BROWNS FERRY NUCLEAR PLANT, UNIT 1
AMENDMENT TO FACILITY OPERATING LICENSE

Amendment No. 224
License No. DPR-33

ATTACHMENT TO LICENSE AMENDMENT NO. 224

Revise the Appendix A Technical Specifications by removing the pages identified below and inserting the enclosed pages. The revised pages are identified by the captioned amendment number and contain marginal lines indicating the area of change. *Overleaf pages are provided to maintain document completeness.

Figure 3.6.-1

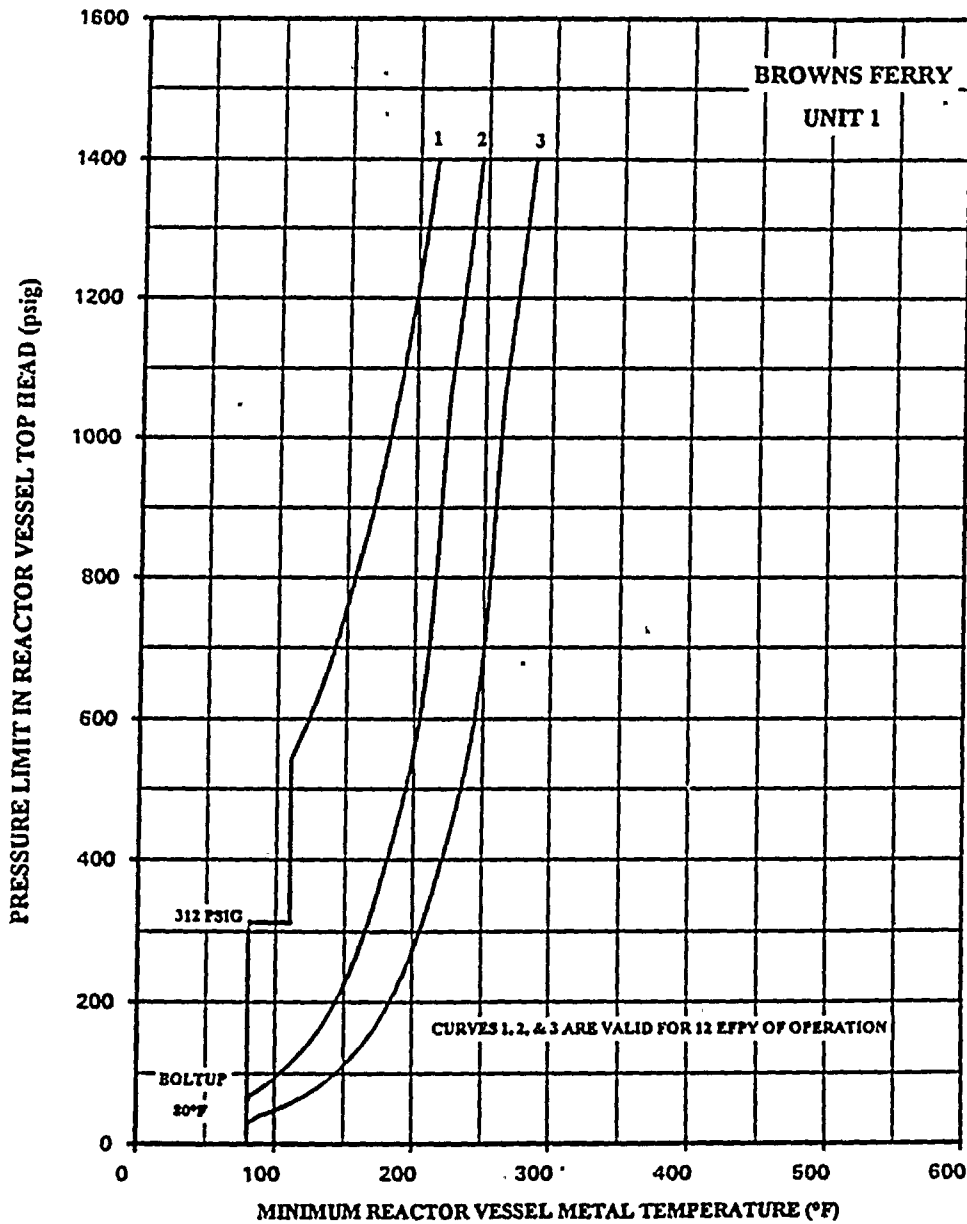
Minimum temperature for pressure tests such as required by Section XI. Minimum temperature of 191°F is required for test pressure of 1,100 psig.

Minimum temperature for mechanical heatup or cooldown following nuclear shutdown.

Minimum temperature for core operation (criticality) includes additional margin required for 10CFR50, Appendix G, Par. IV.A.3 which became effective July 26, 1983.

These curves include sufficient margin to provide protection against feedwater nozzle degradation. The curves allow for shifts in RT_{NDT} of the Reactor vessel beltline materials, in accordance with Reg. Guide 1.99 Rev. 2, to compensate for radiation embrittlement for 12 EFPY.

Figure 3.6.-1

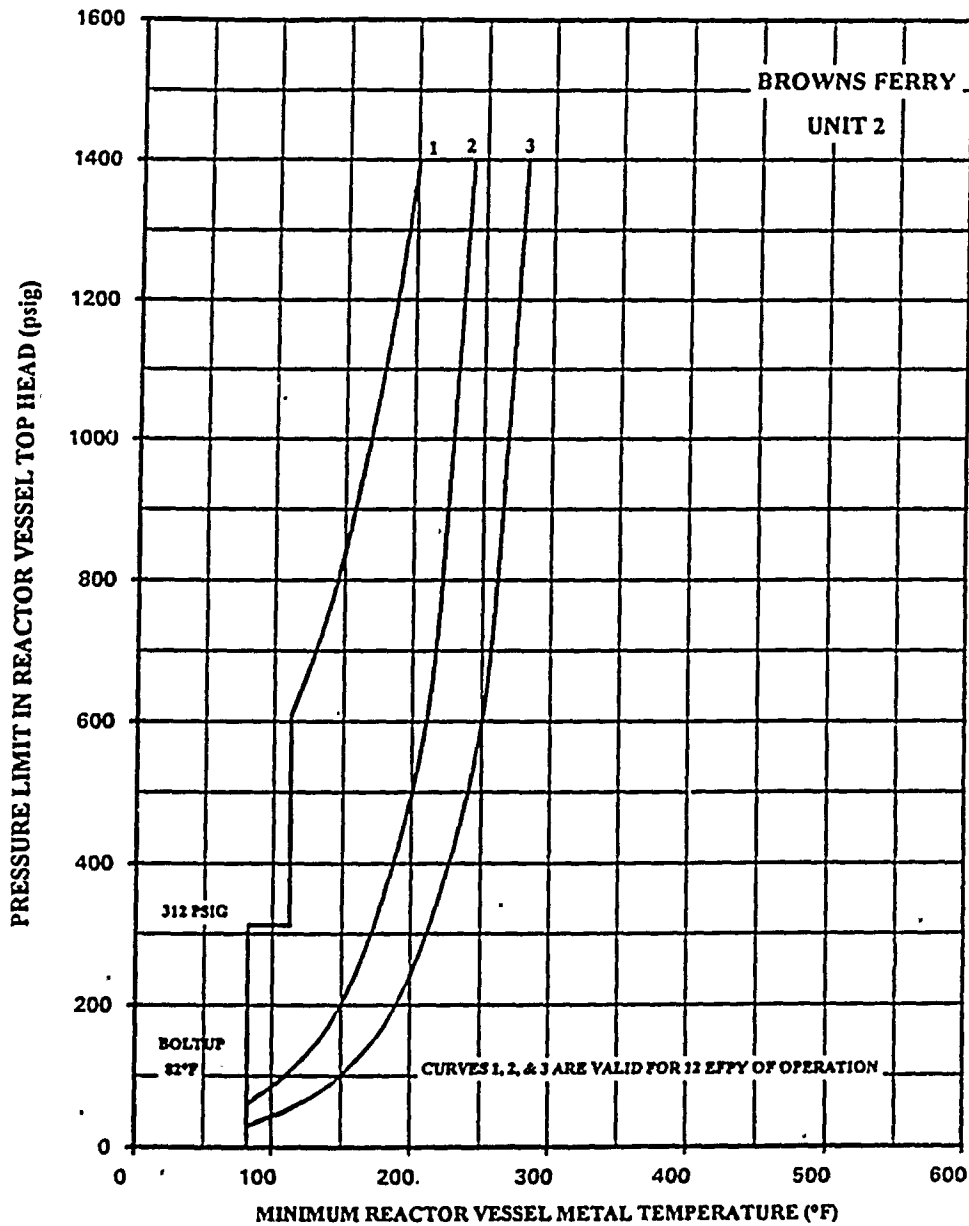
Curve No. 1
 Minimum temperature for pressure tests such as required by Section XI. Minimum temperature of 178° F is required for test pressure of 1,100 psig.

Curve No. 2
 Minimum temperature for mechanical heatup or cooldown following nuclear shutdown.

Curve No. 3
 Minimum temperature for core operation (criticality) includes additional margin required for 10CFR50, Appendix G, Par. IV.A.3 which became effective July 26, 1983.

Notes
 These curves include sufficient margin to provide protection against feedwater nozzle degradation. The curves allow for shifts in RT_{NDT} of the Reactor vessel beltline materials, in accordance with Reg. Guide 1.99 Rev. 2, to compensate for radiation embrittlement for 12 EFPY.

Figure 3.6.-1

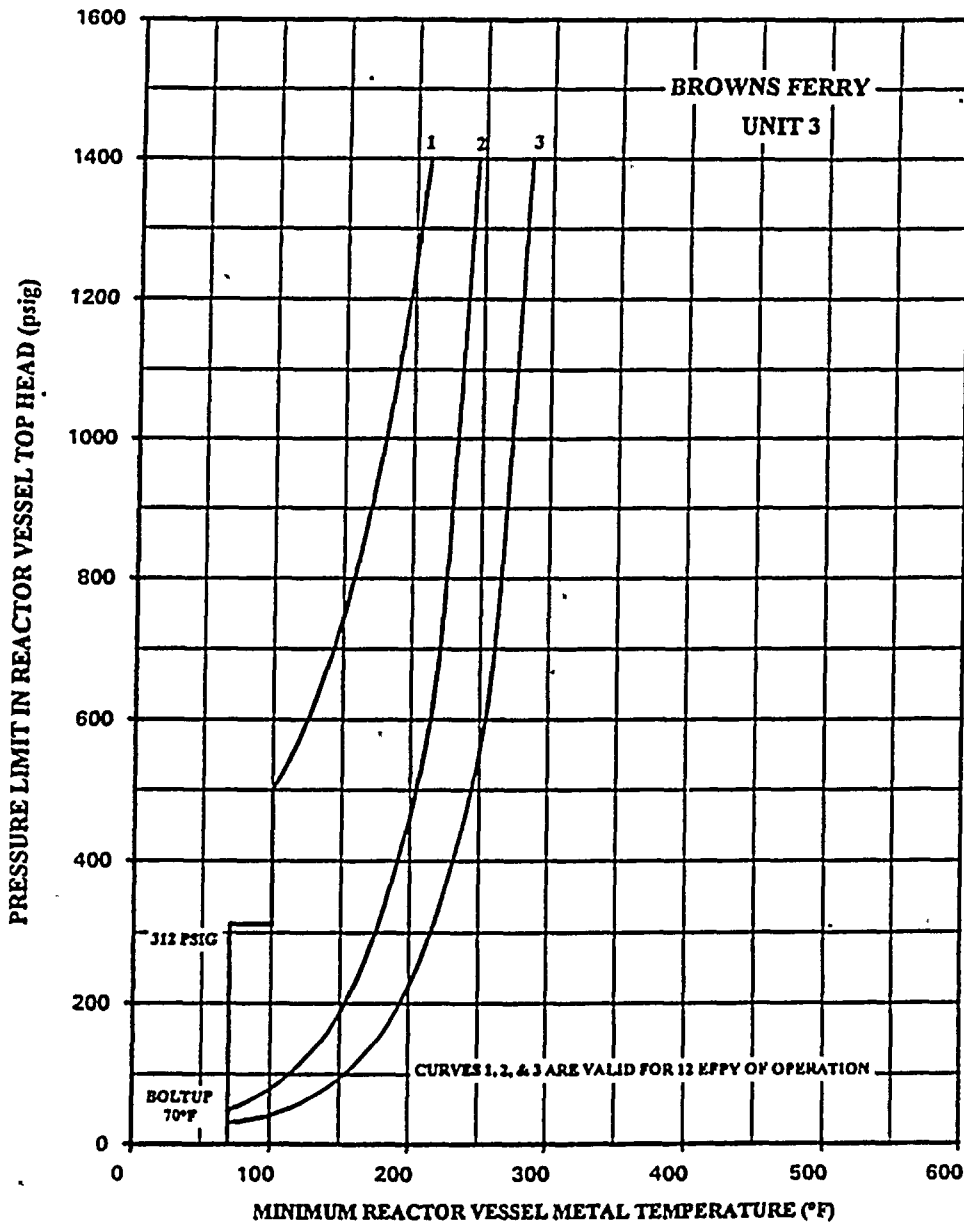
Minimum temperature for pressure tests such as required by Section XI. Minimum temperature of 189°F is required for test pressure of 1,100 psig.

Minimum temperature for mechanical heatup or cooldown following nuclear shutdown.

Minimum temperature for core operation (criticality) includes additional margin required for 10CFR50, Appendix G, Par. IV.A.3 which became effective July 26, 1983.

These curves include sufficient margin to provide protection against feedwater nozzle degradation. The curves allow for shifts in RT_{NDT} of the Reactor vessel belline materials, in accordance with Reg. Guide 1.99 Rev. 2, to compensate for radiation embrittlement for 12 EFPY.
